# IF USING GASKET (SN0270-WT) PLEASE SEE THE BELOW RECOMMENDATION

GASKET SN0270-WT

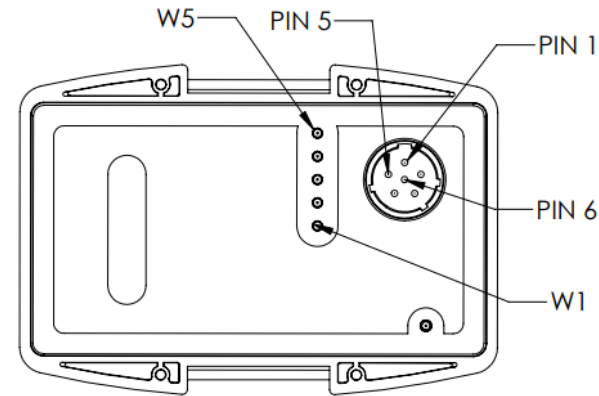
IT IS RECOMMENDED TO RAISE THE POGO PIN SHELLS BY .10 INCHES FOR BETTER CONTACT WITH BATTERY SMBUS.  
NOTE: POGO PINS WILL STILL CONTACT SMBUS IF NOT RAISED.
